SERVICE BULLETIN 00134 REV 2.2

Subject: Horizontal Stabilizer Forward Attach Bolt Position

Affected Models: RV-4, RV-6/6A, RV-7/7A, RV-8/8A

FIGURE 1: LONGERON REDUCED EDGE DISTANCE
(HORIZONTAL AND TOP DECK REMOVED)

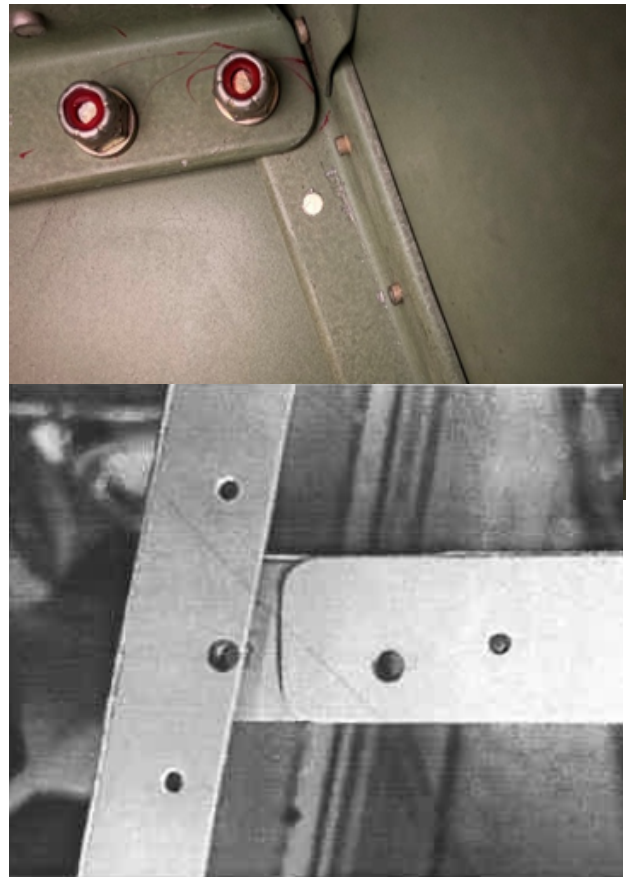
The strength of this joint and the airframe structure as a whole is relatively tolerant of variations in the outermost bolt hole position in the fuselage longerons, even where this involves less than what are normally considered minimum edge distances, zero edge distance and even bolt holes cutting through the inner edge of the longeron flange.

In the fuselage longeron, spanwise locations of the outermost bolt positions that result in the hole for the outboard bolt having a reduced edge margin in the longeron, cutting through the inboard edge of the longeron or missing the longeron altogether are acceptable. See Figure 1.

FIGURE 2: RV-7 DEG 27A TYPICAL HORIZONTAL STABILIZER ATTACH FRONT VIEW

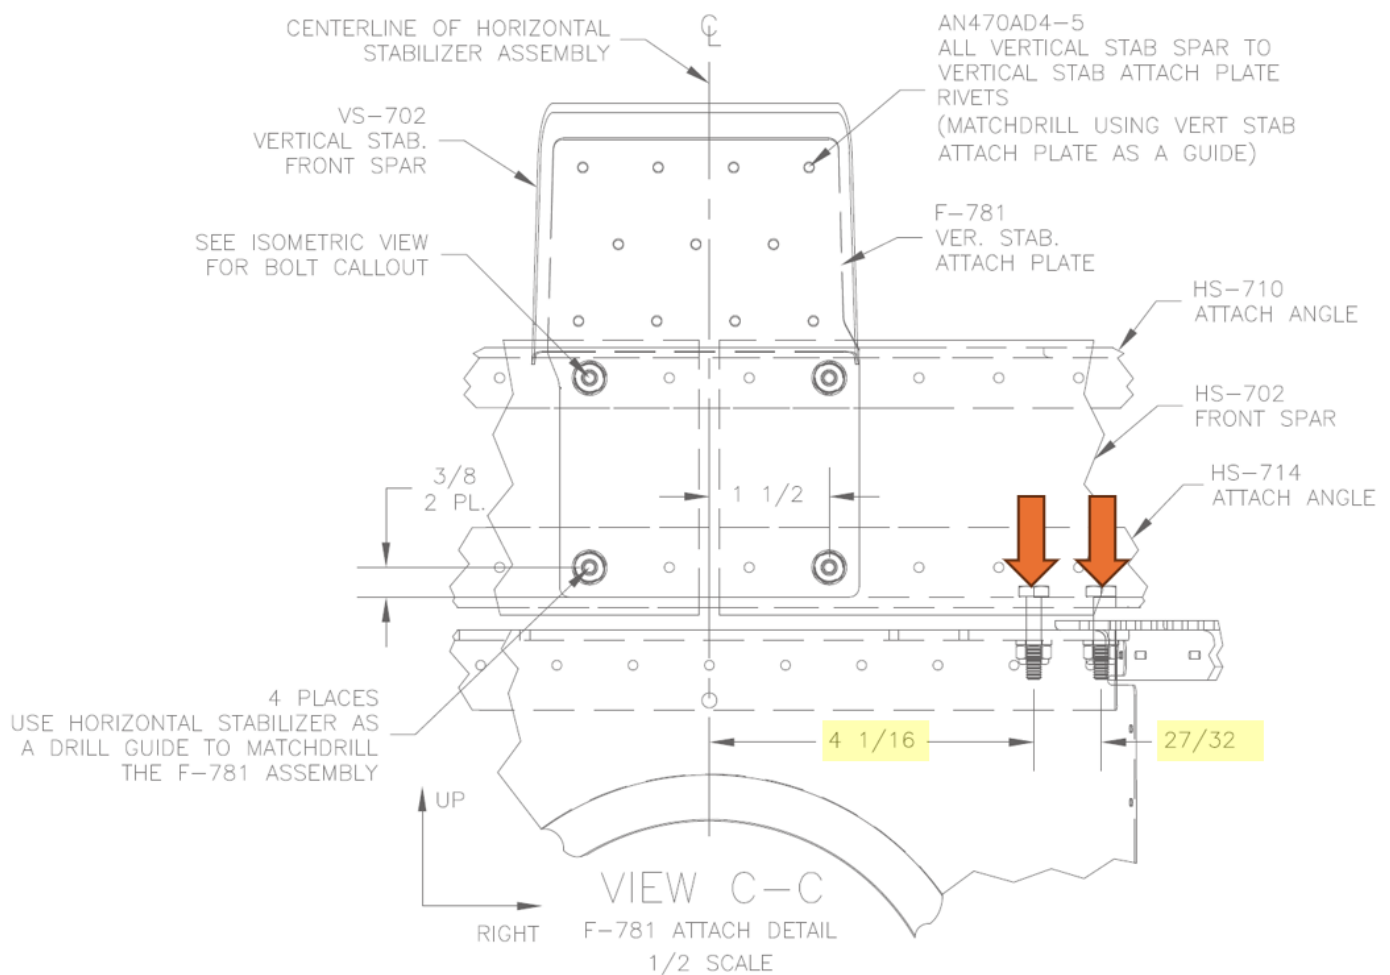
Step 2: Measure the distance between the attach bolts on one side of the aircraft (see the set of bolts marked with arrows in Figure 2 with a distance of 27/32 inches between them). At minimum the distance between the bolts should be 25/32 inches.

Measure the edge distance between the center of each bolt hole and the forward edge of the HS-714 Attach Angle. Repeat the measurement for the forward edge of the F-710B Angle. See Figure 2 and Figure 3. The edge distance should not be less than $e/D = 1.5$ (e/D the distance from the center of a hole to the edge of the part divided by the diameter of the hole $.190 \times 1.5 = .28$ in).

For example, Figure 2 the center of the bolt pattern would be $4 \frac{1}{16}$ inches plus half the distance between the bolts or half of $\frac{27}{32}$ inches which results in a bolt pattern center distance to the centerline of 4.48 inches.

A hole spacing less than 25/32 inches but not less than 1/2 inch is acceptable provided that the areas shown in Figure 6 and the areas between the bolts are carefully inspected at each annual or 100-hour intervals whichever comes first (the relief notch within the red box in the figure and the angle inside radius within the blue box). If the distance is less than 1/2 inch contact Van's Aircraft for further assistance.

An edge distance less than $e/D = 1.5$ (.28 in) but not less than $e/D = 1.0$ (.19 in) is acceptable provided that the areas shown in Figure 6 are carefully inspected at each annual or 100-hour intervals whichever comes first (the relief notch within the red box in the figure and the angle inside radius within the blue box).

FIGURE 4: ACCEPTABLE BOLT POSITION CHART

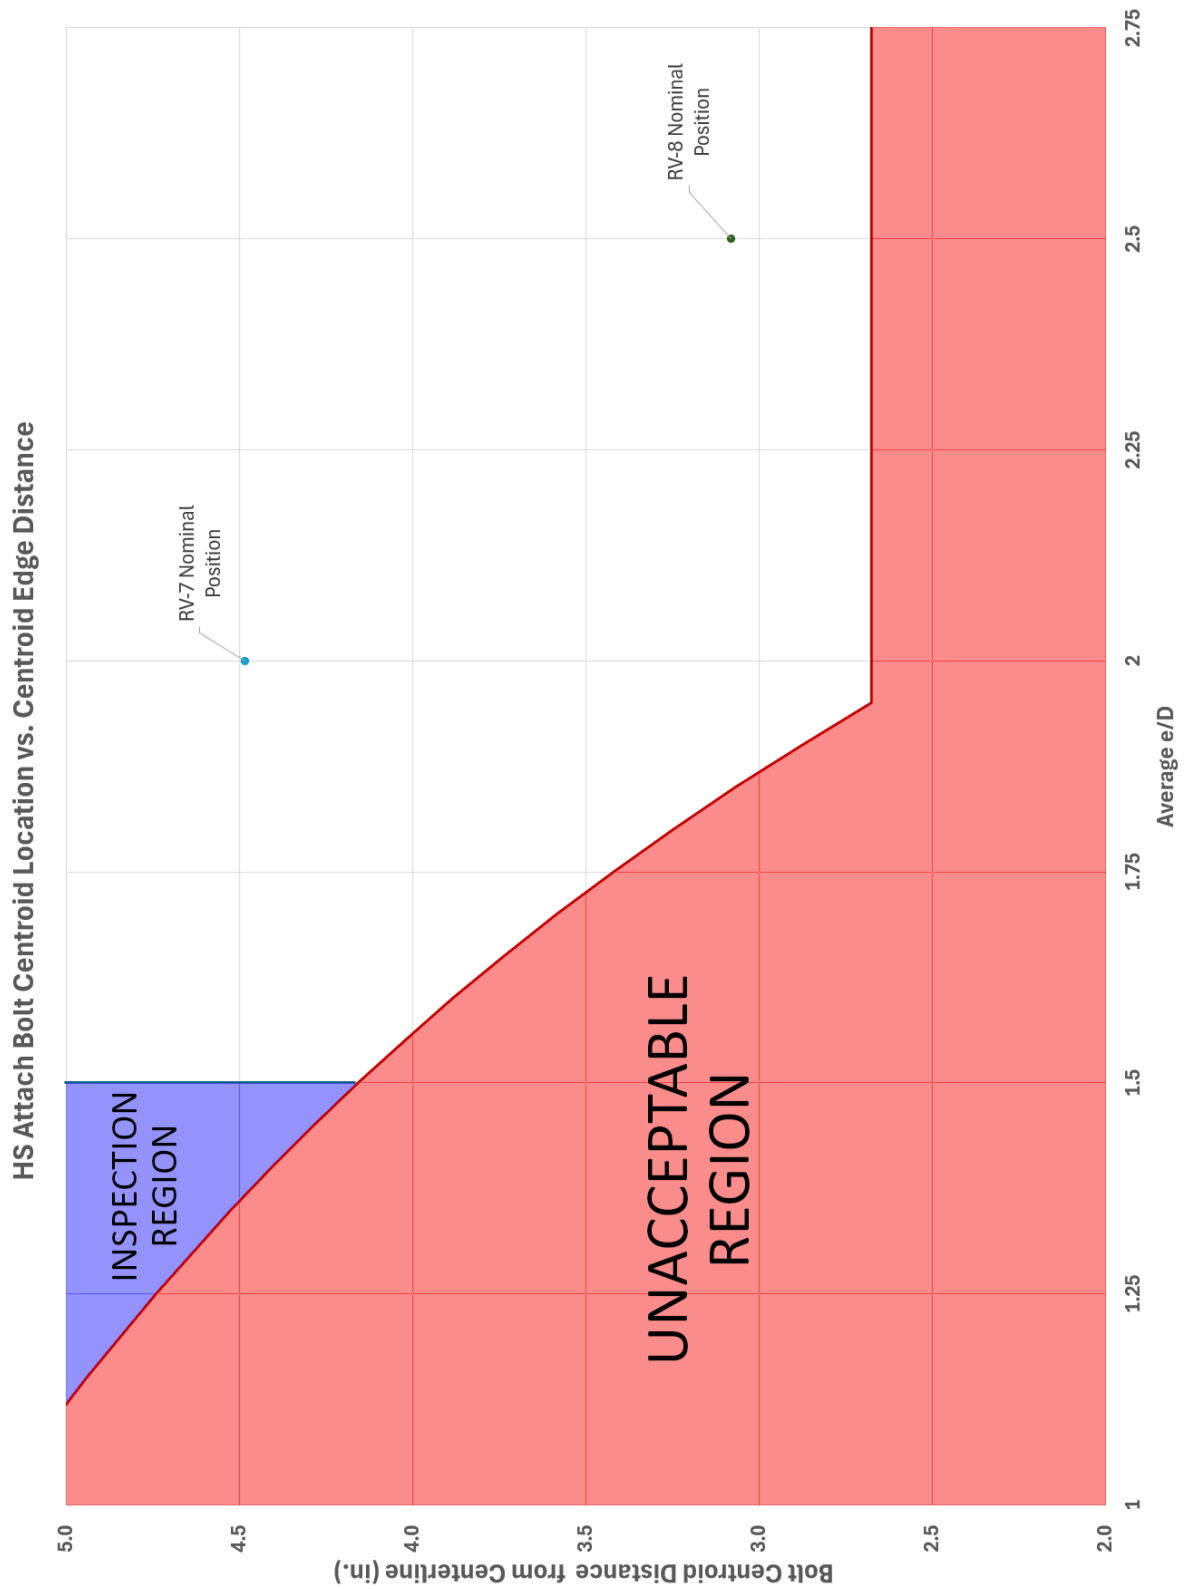
Step 5: Plot the average e/D value for the center of the bolt pattern and the forward edge of the HS-714 Attach Angle from Step 3 and the bolt pattern center distance to the centerline measured in Step 4. The plotted point must be outside the unacceptable region noted in Figure 4.

For example, the bolt pattern distance from Step 4 was 4.484 inches. Assume the nominal e/D of 2 (.38 in) of the center of the bolt pattern. This example corresponds to the RV-7 nominal point given on the chart in Figure 4. If the point on the chart is within the unacceptable area on the chart contact Van's Aircraft for further assistance.

FIGURE 5: OUTBOARD BOLT POSITION & e/D

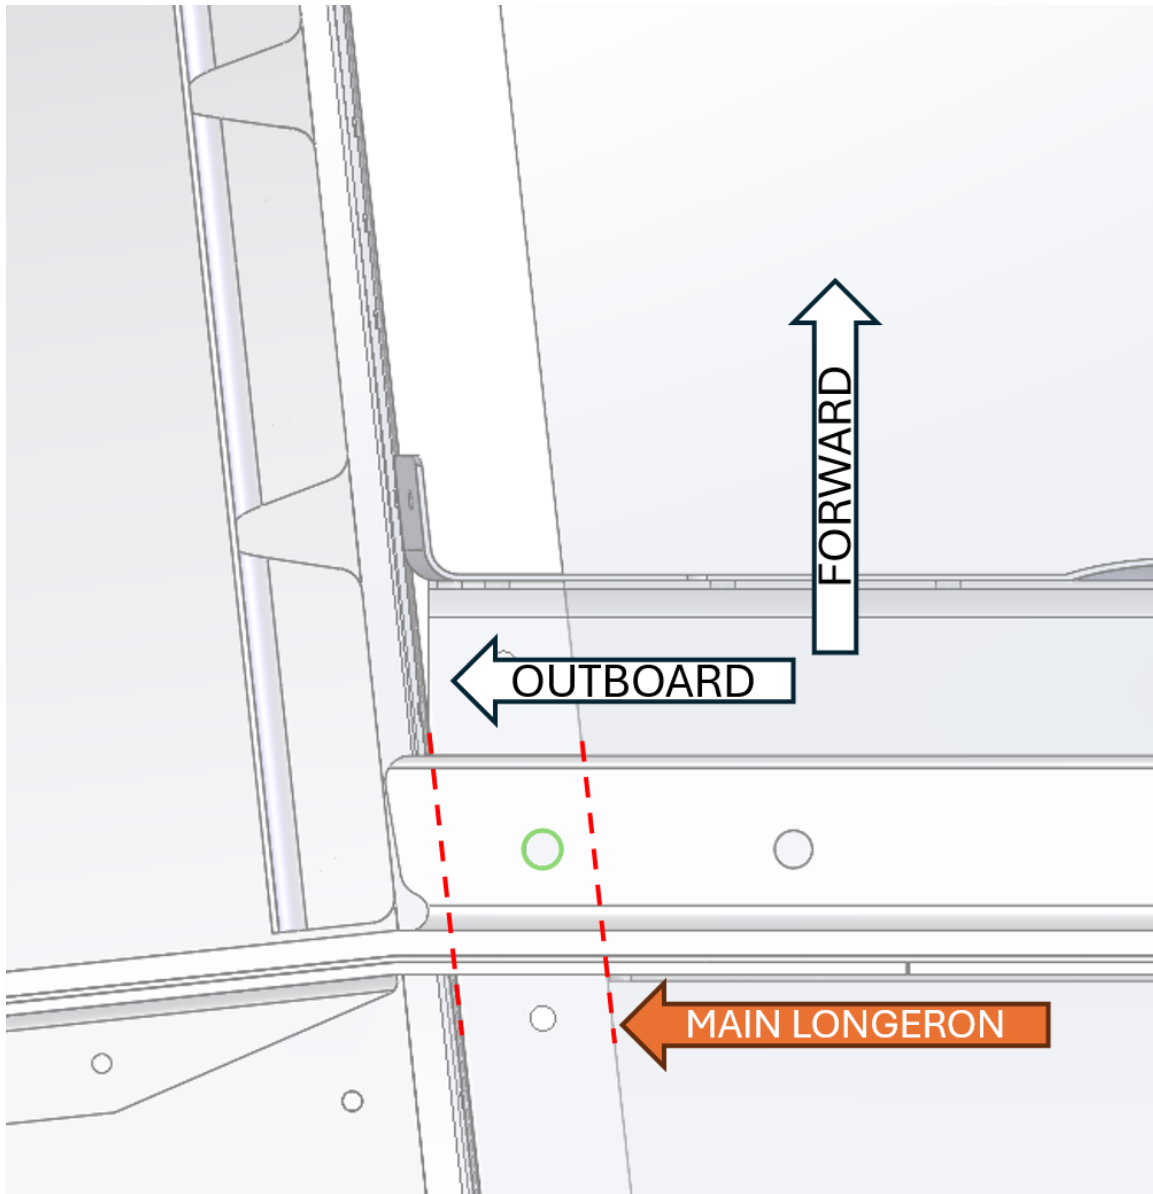
If the entire diameter of the outboard most bolt hole is within boundary of the main longeron (see Figure 5) and if the inboard bolt meets the criteria of Step 3A $e/D = 1.5$ (.28 in) and Step 4 and Step 5 (below) then an edge distance $e/D = .25$ (.05 in) is acceptable.

If the e/D is less than those specified above or the outboard end of F-710B is not resting on the F-718 Longerons, contact Van's Aircraft for further assistance.

FIGURE 6: INSPECTION LOCATIONS

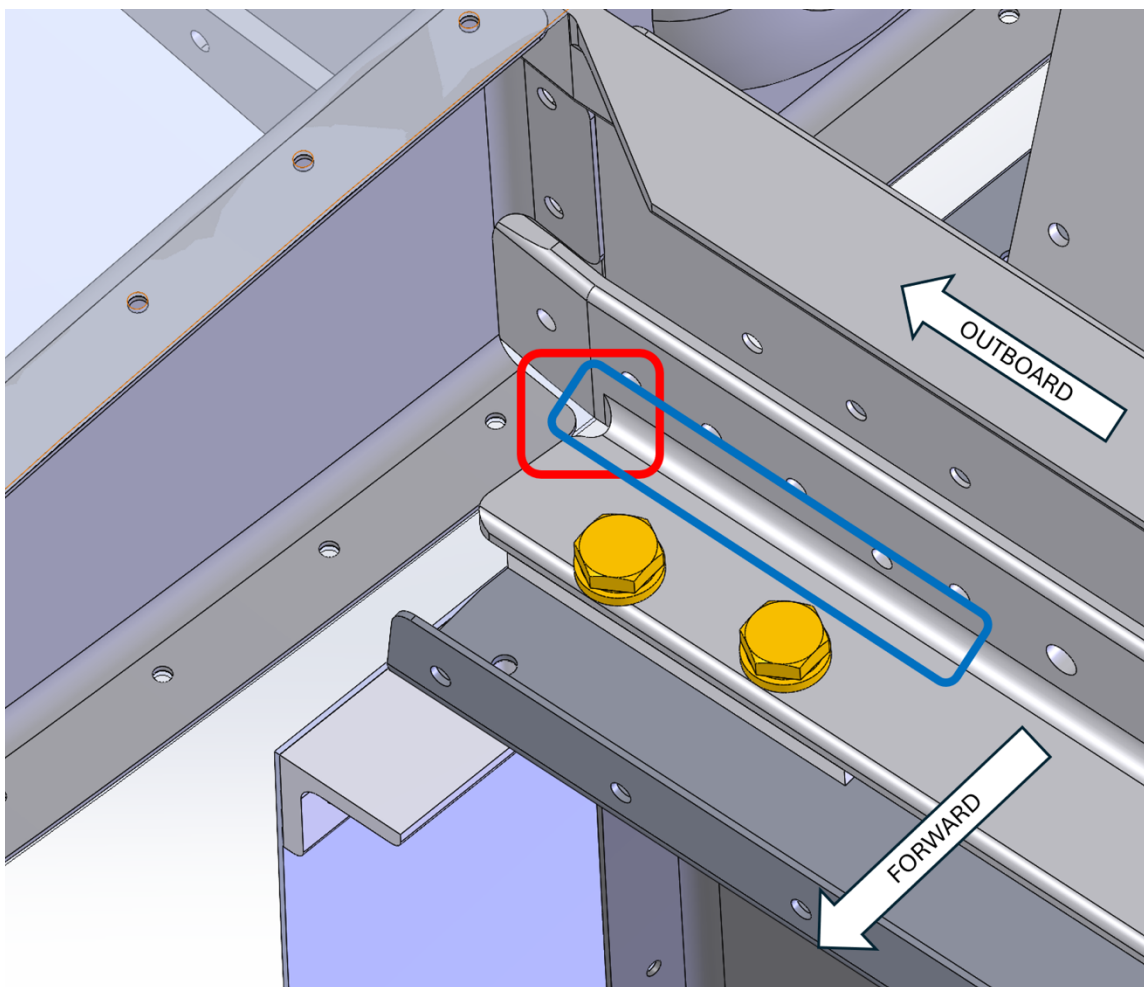
Any trim condition inboard of the trim profile shown within KAI but not greater than the maximum depth and criteria stated above and shown in Figure 9 is acceptable provided that the area within the red box shown in Figure 6 is carefully inspected at each annual or 100-hour intervals whichever comes first.

FIGURE 9: RELIEF NOTCH DETAILS

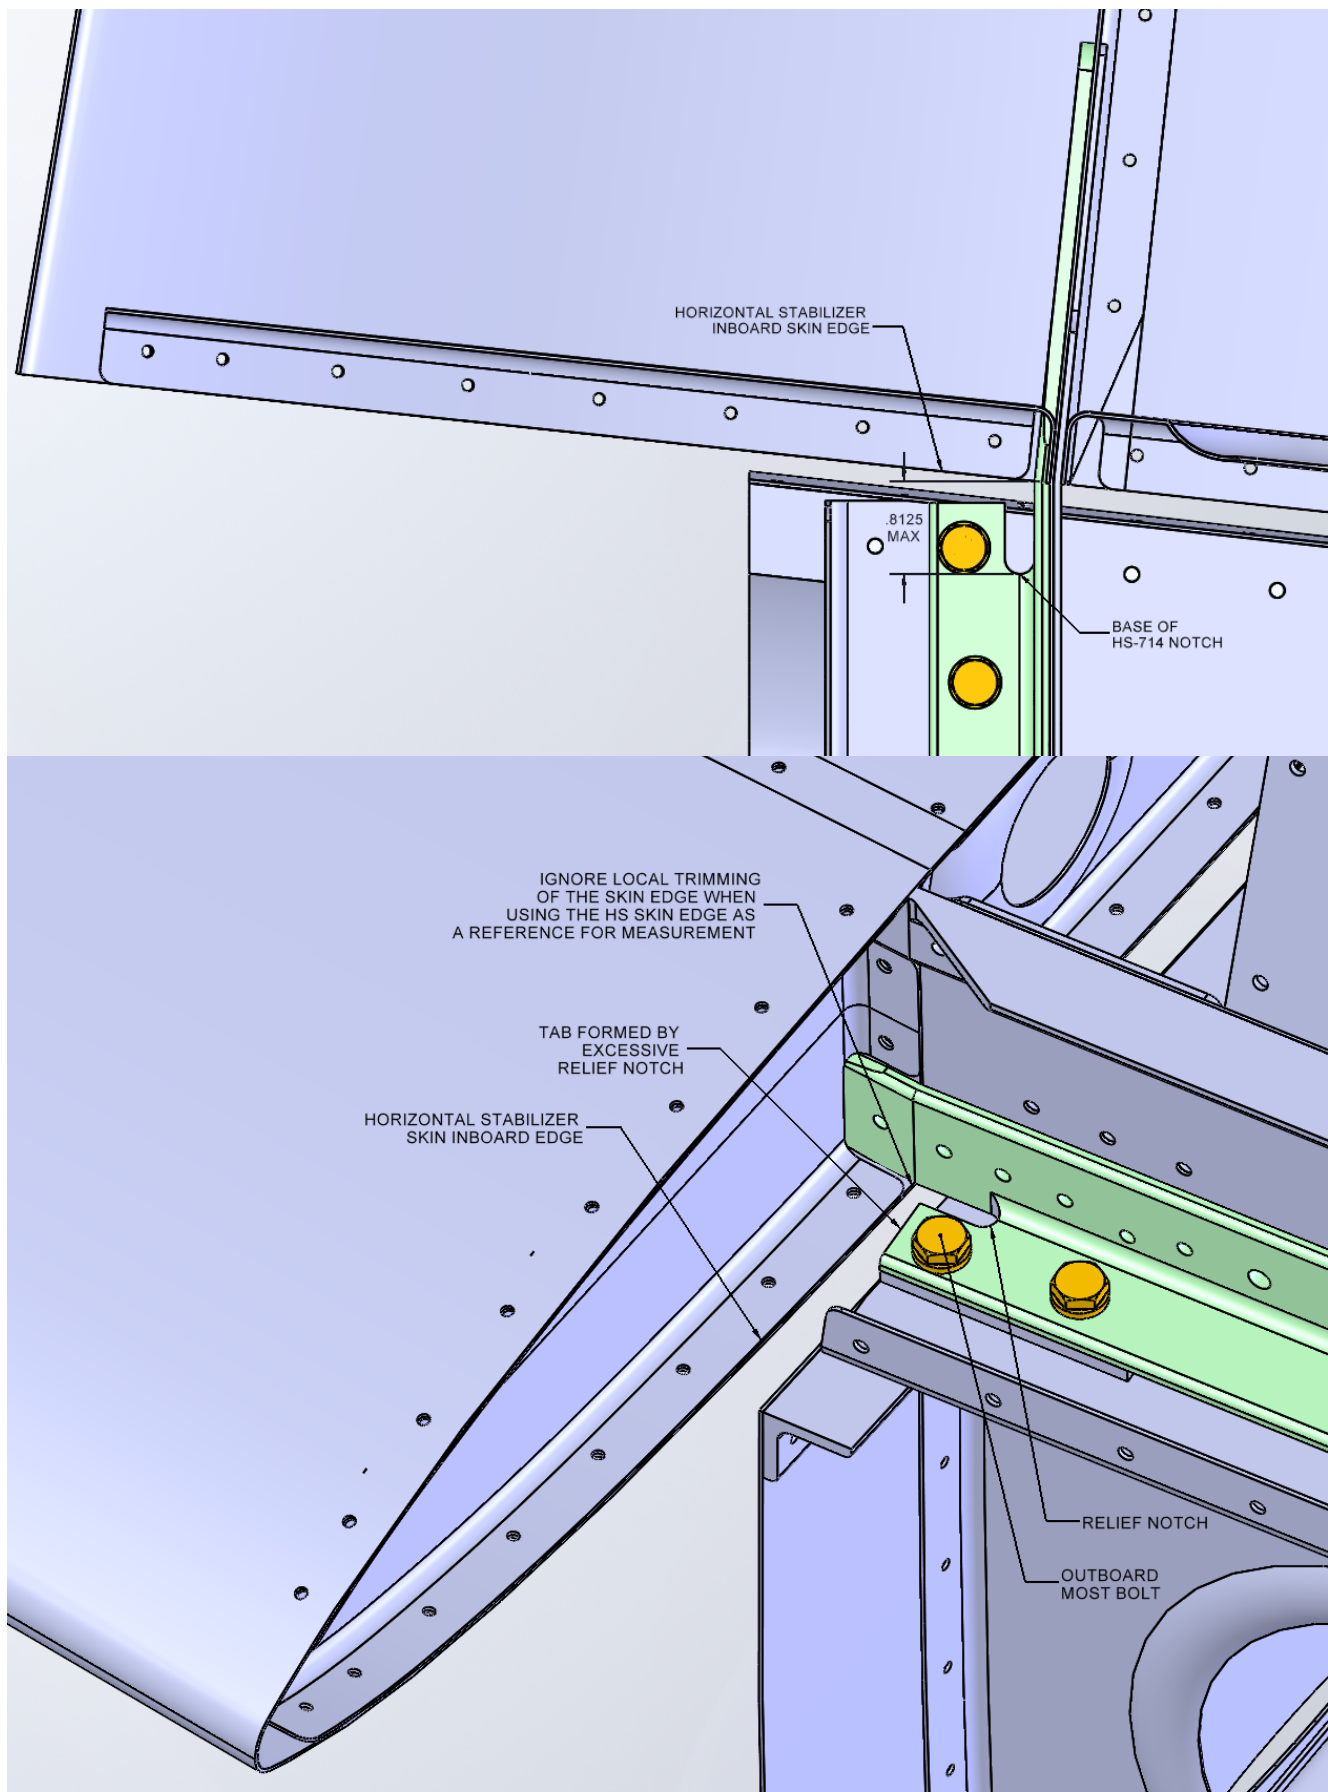
Some notches are excessive and have effectively formed a tab on which the outboard most attach bolt is positioned as shown in Figure 9. This is permissible if the inboard edge of the notch meets the criteria above.

FIGURE 10: WASHER PLATE

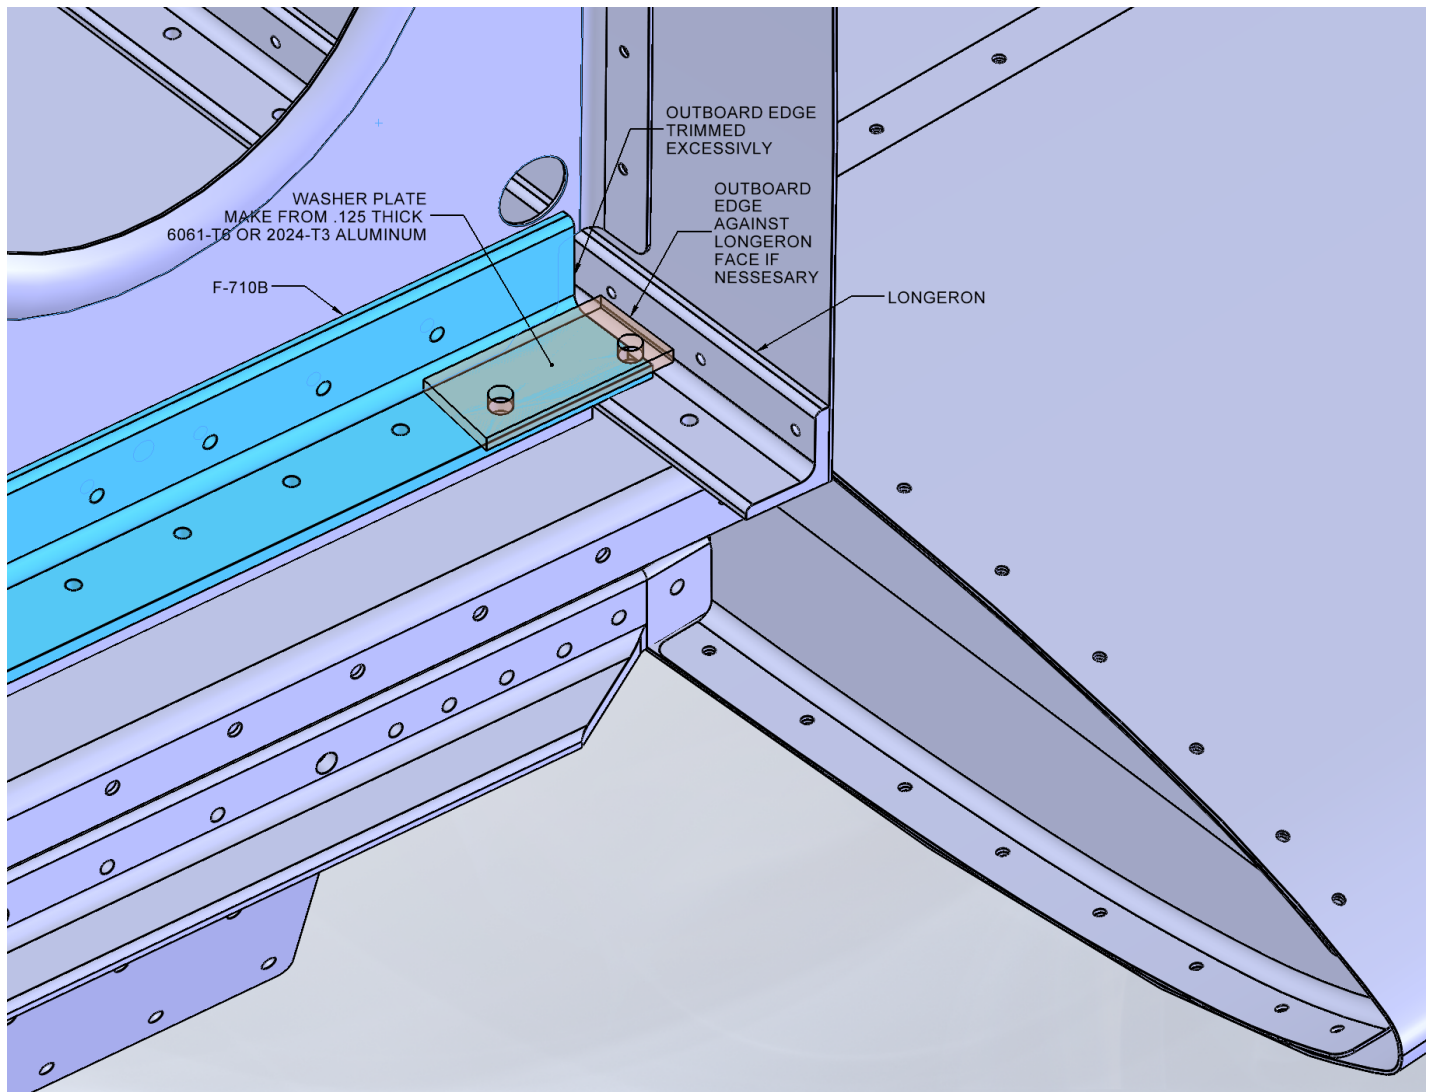
For e/D 's less than .875 (.17 in) and equal to or greater than .25 (.05 in) a washer plate capturing both bolts shall be installed. See Figure 10. The plate shall be made from .125 thick 6061-T6 or 2024-T3 aluminum. The plate shall have at minimum an $e/D = 1.0$ (.19 in) spanwise edge distance for the outboard most bolt and maintain a 1.5 (.28 in) to 2 (.38 in) e/D elsewhere. The plate must rest in full contact with the flat area of F-710B ie not be held off by the fillet radius of the F-710B, rivet heads or other features.
